CITY OF PORTLAND, OREGON

Land Use Review Appeal to
Portland City Council

Appeal of Design Commission Decision
LU 16-184524 DZM

1122 SE Ankeny

HEIGHT

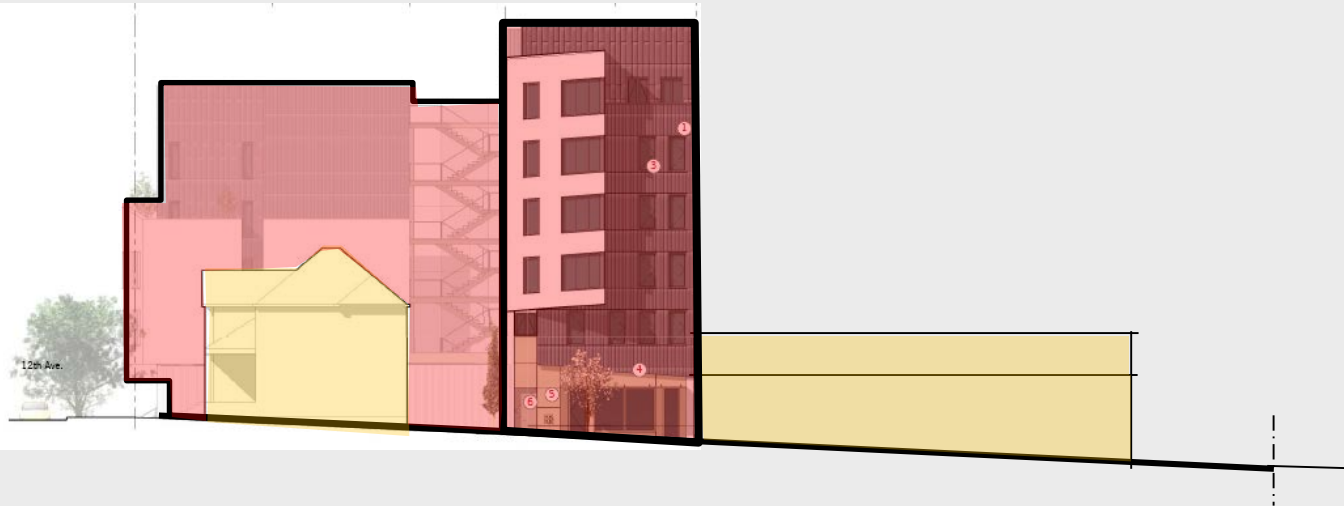
- The Commission provided input on how to improve the sidewalk conditions to meet the guidelines. **Suggestions included shifting the height away from SE 12th towards the west of the site, and providing side setbacks to adjacent residential, while maintaining desired unit counts.**

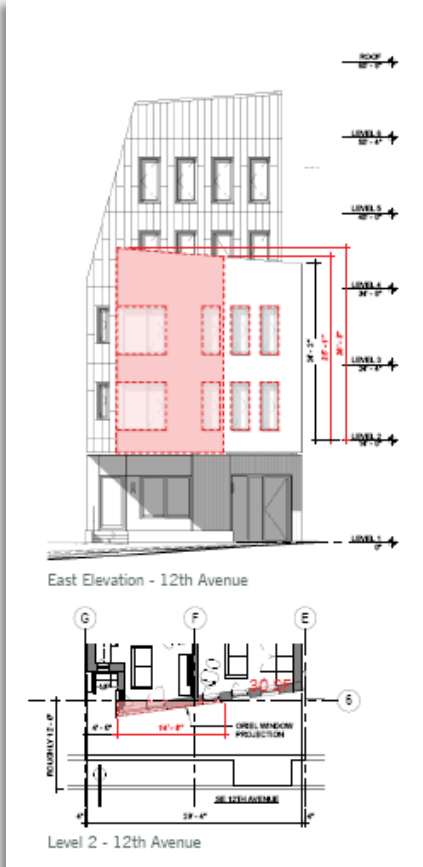
2. The applicant made changes to the stairwell lighting, however, the **6-story tall open stairwells** themselves were found to be not compatible with the adjacent residential rear yards due to concerns about light and noise spill-out.

3. The applicant made changes to the material choices, however, the **large expanses of metal-clad sidewalls** were found to not be compatible with the adjacent residential context.
